AMENDMENTS			
No.	Revision Description	Date	Issued by
1	Issued For QS review	30.09.19	
2	80% REVIEW	18.10.19	
3	80% ISSUE	14.11.19	
4	TENDER - DRAFT	11.12.19	
5	TENDER ISSUE	18.12.19	
6	MARKED UP WITH FENCING DETAILS	21.06.20

GMC RUG
SINCLAIR STREET, GOULBURN

Title:
RH - SITE PLAN

PROPOSED SITE FENCING DETAILS

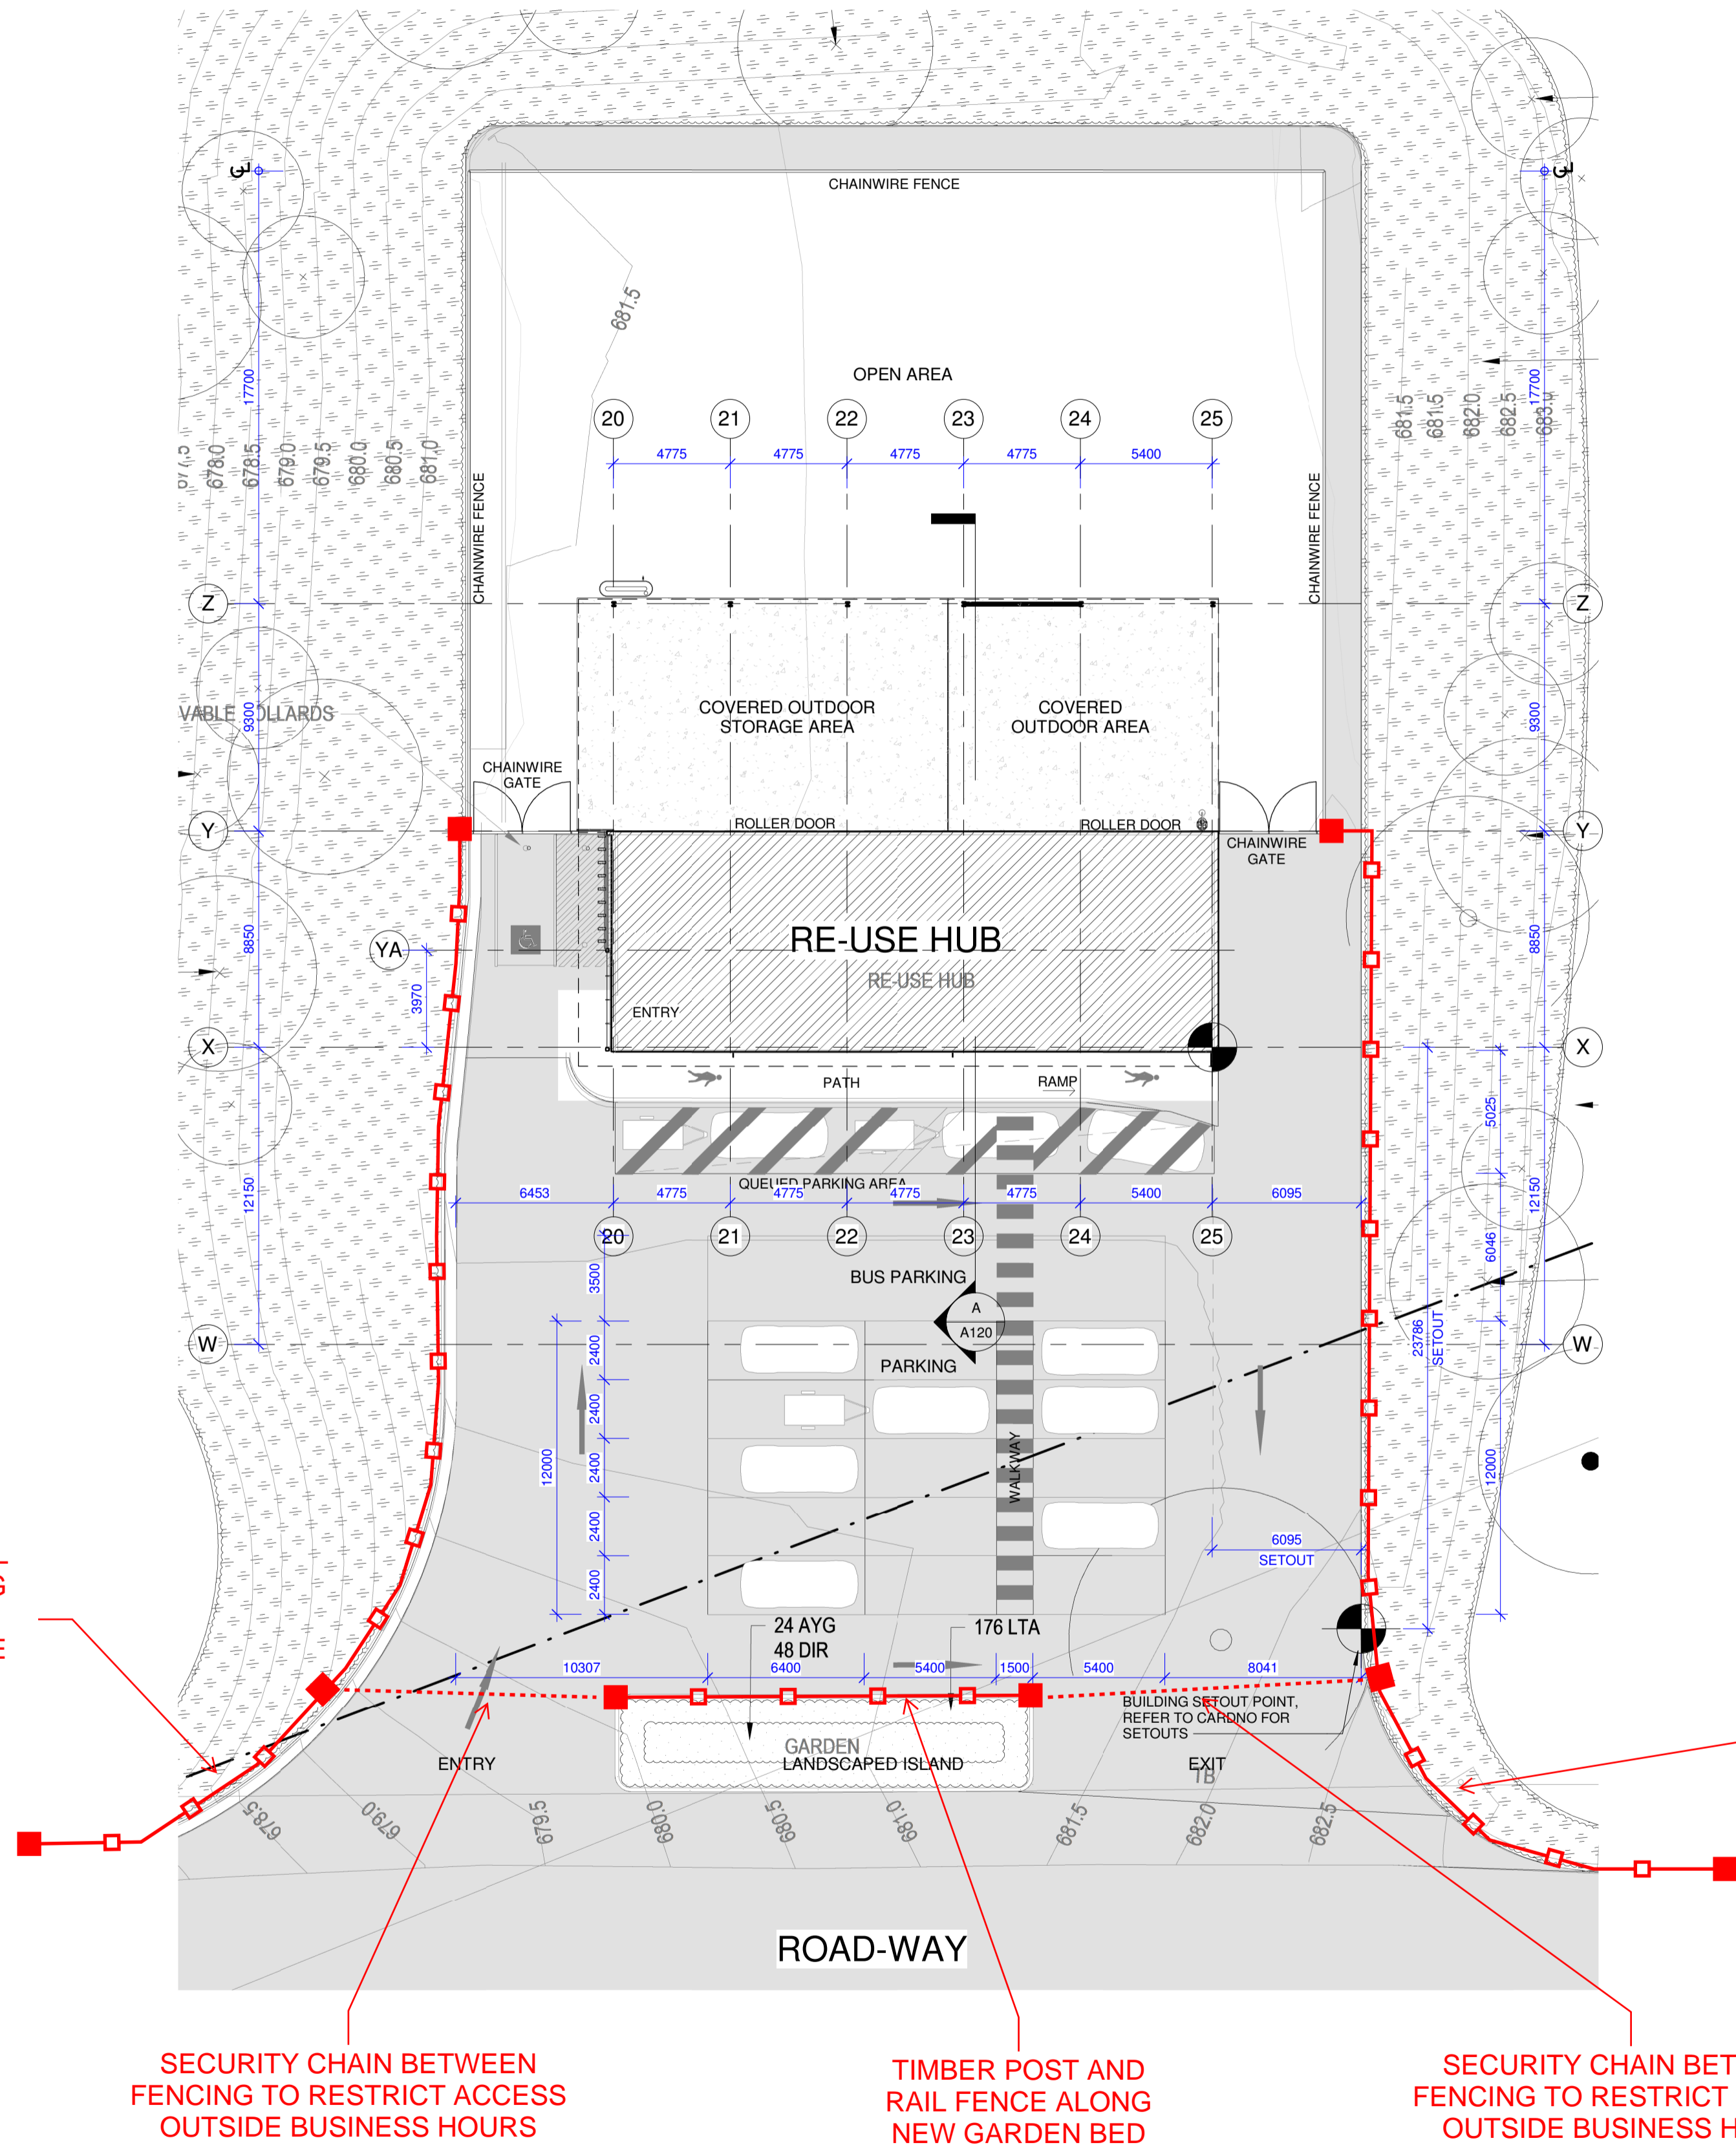
INDICATIVE TIMBER POST AND RAIL FENCE TYPES

TIMBER POST AND RAIL FENCE FROM EXISTING BOUNDARY FENCE ON SINCLAIR ST TO REUSE HUB FENCING

TIMBER POST AND RAIL FENCE FROM EXISTING BOUNDARY FENCE ON SINCLAIR ST TO REUSE HUB FENCING

SECURITY CHAIN BETWEEN FENCING TO RESTRICT ACCESS OUTSIDE BUSINESS HOURS

TIMBER POST AND RAIL FENCE ALONG NEW GARDEN BED

SECURITY CHAIN BETWEEN FENCING TO RESTRICT ACCESS OUTSIDE BUSINESS HOURS
